PROJECT CASE STUDY

Sun Trail SUP Concept and Typical Section

St. Johns County Sun Trail, St. A1A/ Beach Blvd from SR A1A to Pope Road, St. Augustine, FL

The Department has requested that AtkinsRéalis review the latest typical section and provide comments regarding the design, safety, and predicted crash impacts associated with the concept.

Figure 1 - Typical Section Proposed

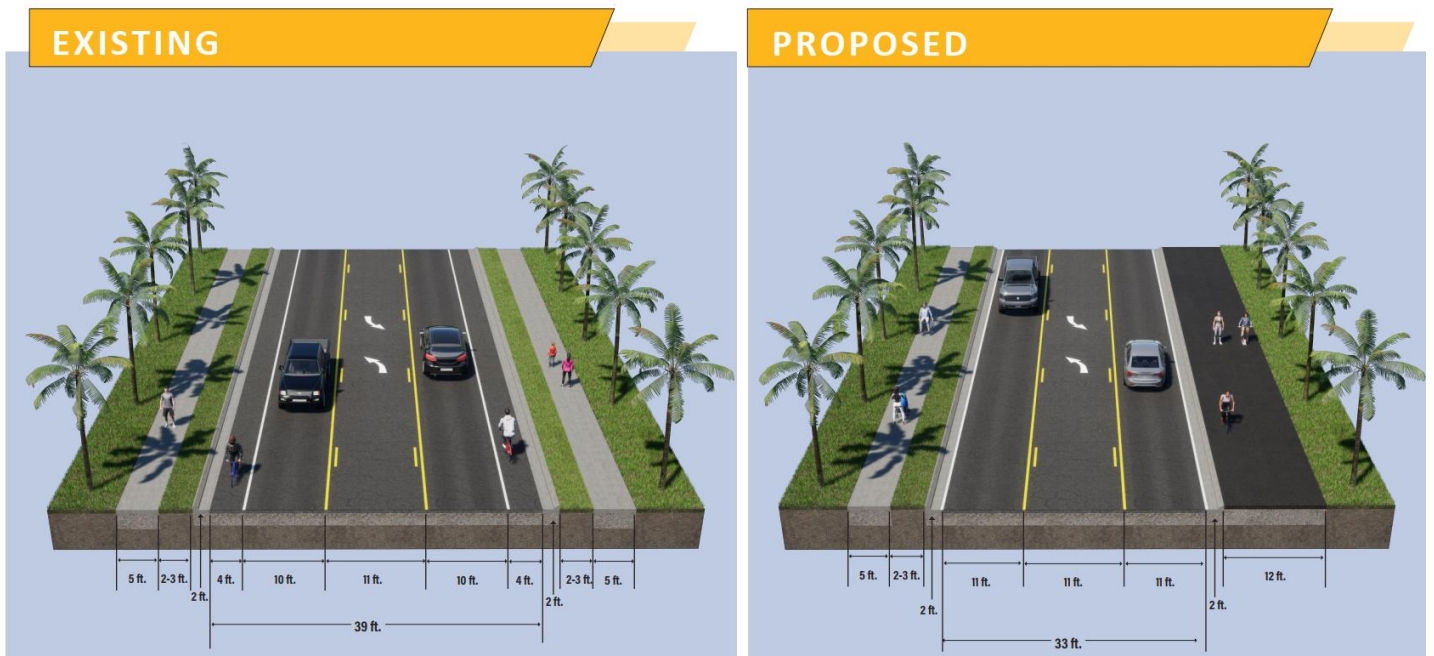
- **Comparison of Proposed Concept to FDM 224-Shared Use Paths**
 - **Separation** – For SUP on curbed roadways, the **edge of the path is to be at least 5-ft from the face of the curb** (FDM 224.12)
 - **Design Concern: Proposed SUP is flush with curb.** If concept uses SUP, increase separation by 5-ft. (See Figure 1 for example of typical section)

- **Separation** - For Urban Side Paths, place as close to the R/W line as possible, **but no closer than 2 feet from the back of curb.**
 - **Design Concern: Proposed SUP is flush with curb.** If Urban Side Path, increase separation by 2-ft.

- Eliminates roadway shoulder.
- Shared path is proposed adjacent to the roadway with no buffer, which puts pedestrians and recreational riders closer to traffic than existing design does. However, a 12-ft path allows for greater maneuverability and operating space which could compensate for some of the lack of buffer. This could be resolved to decreasing the path width to 10-ft with a 2-ft buffer to the curb in constrained areas.
- May increase bicycle crossings from west side of road to east to reach the SUP.
- The SUP concept shows closures in vehicular access for some side street locations east of roadway.

Qualitatively the proposed concept converts a physically separated sidewalk to a path with no separation with the roadway. This increased the opportunity for inexperienced users to travel off the sidewalk and directly into the roadway. In the existing condition the physical separation between the edge of vehicle travel lanes and the sidewalk is 6 feet, and in the proposed this is reduced to 2 feet.

In summary, it is recommended that the SUP be reimagined with a lateral separation of at least 2-ft from the edge of the travel lanes. This provides physical and visual separation between vehicle and bicycle/pedestrian modes of travel.

This **quantitative review below assumes that the SUP design will be revised to incorporate separation between the back of curb and the edge of the SUP**. The FDM criteria requires at least a 2-ft separation between the two.

Figure 2 – FDM Typical Section of SUP

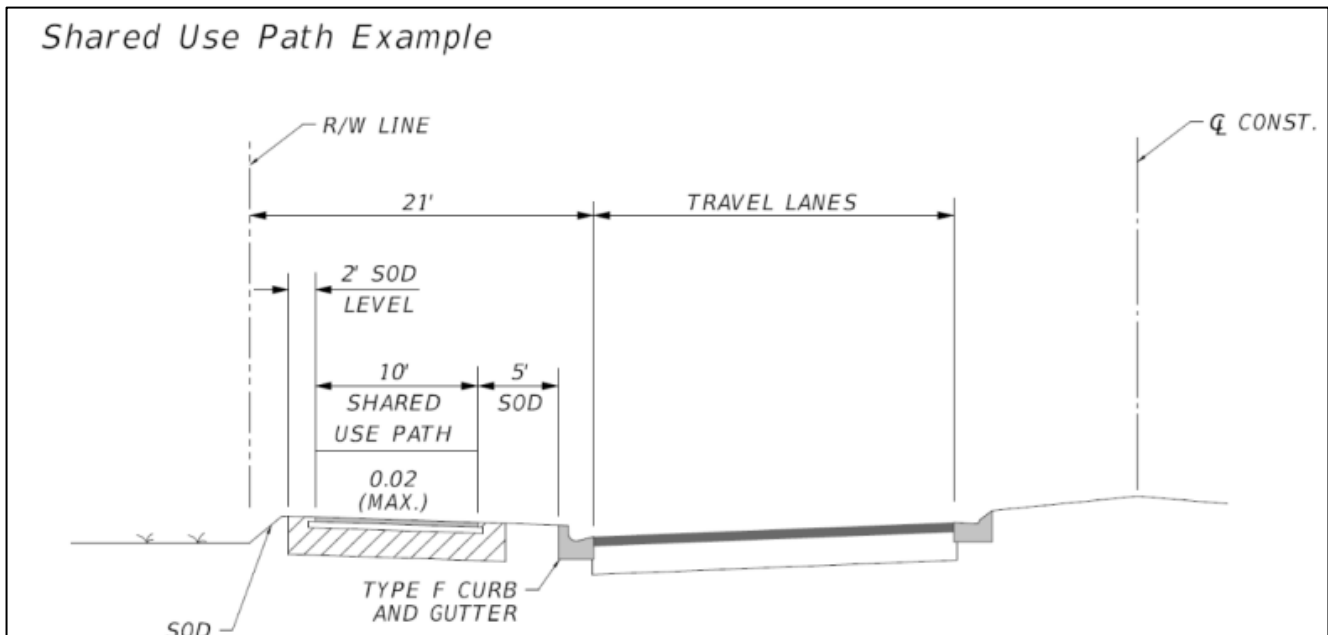
- **Applicability of the Urban Side Path**
 - **Context Classification:** An Urban Side Path is a category of SUP that may be used in **C2T, C4, C5, and C6** context classifications where the design speed of the adjacent roadway is 35 mph or less.

- **The project location can be classified as either C2T or C4**
 - Urban Side Path Notes from FDM 224
 - The Urban Side Path users and motorists in adjacent travel lanes will be traveling more slowly in C2T, C4, C5, and C6 context classifications, compared to the rural and suburban locations of conventional shared use paths. In addition, because they are associated with curbed roadways, Urban Side Paths will be vertically separated from the roadway, further distinguishing them from conventional shared use paths. The slower travel speeds and vertical separation allow the use of design criteria differing from a standard shared use path. The slower travel speeds are due to speed management concepts inherent to the urban environment (e.g., enclosure, engagement, and deflection).
